Title: Mechanical & Electrical Upgrades, New Delhi, India

Solicitation Number: 21-175731

Questions & Answers # 3

PHYSICAL POINT LIST

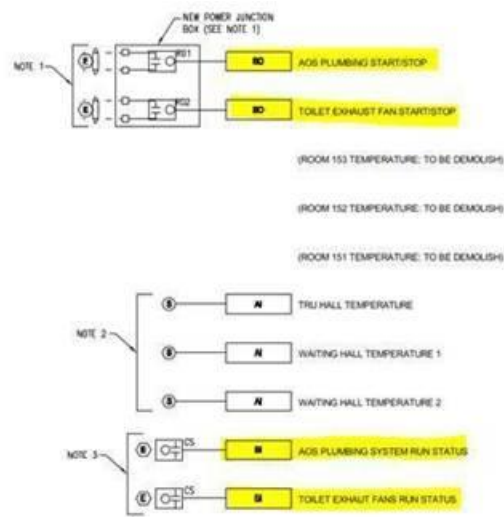
Q26. “We understand that Johnson Controls is the specified vendor and vital part of the tender requirement. The quantity of the Toilet Exhaust Fans and AOS Plumbing system is not clear from HVAC BOQ & from drawings. Please provide quantity for the same. Also please confirm the quantity of the field devices.”

A26. Except for RTU-x’s points, which are typical, the physical point list shown on the control drawing is exhaustive. So there is respectively only one (1) occurrence of “Toilet Exhaust” and one (1) occurrence of “AOS Plumbing”. Each occurrence having 1 BO and 1 BI.

Accordingly, the “MISCELLANEOUS COMMANDS AND MONITORING POINTS” drawing shows the only 2 BO and 2 BI for these occurrences.

BMS NETWORK ARCHITECTURE

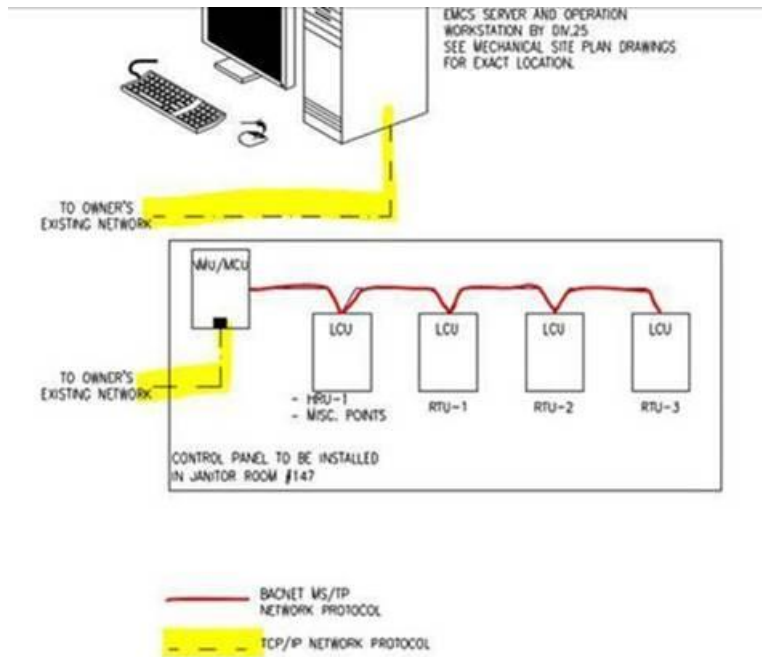
Q27. “As mentioned in the drawings BACNET MSTP network protocol needs to be used. Please confirm whether we need to use MSTP network or IP network for DDC controllers.”

A27. As shown in the BMS Network Architecture, the sub-network between LCU DDC controllers has to be BACnet MS/TP (running on RS-485 serial bus). Only the NMU and the computer workstation have to be connected using TCP/IP protocol.

The number of DDC controllers needed are also shown on the BMS Network Architecture:
1 NMU; 4 LCUs.
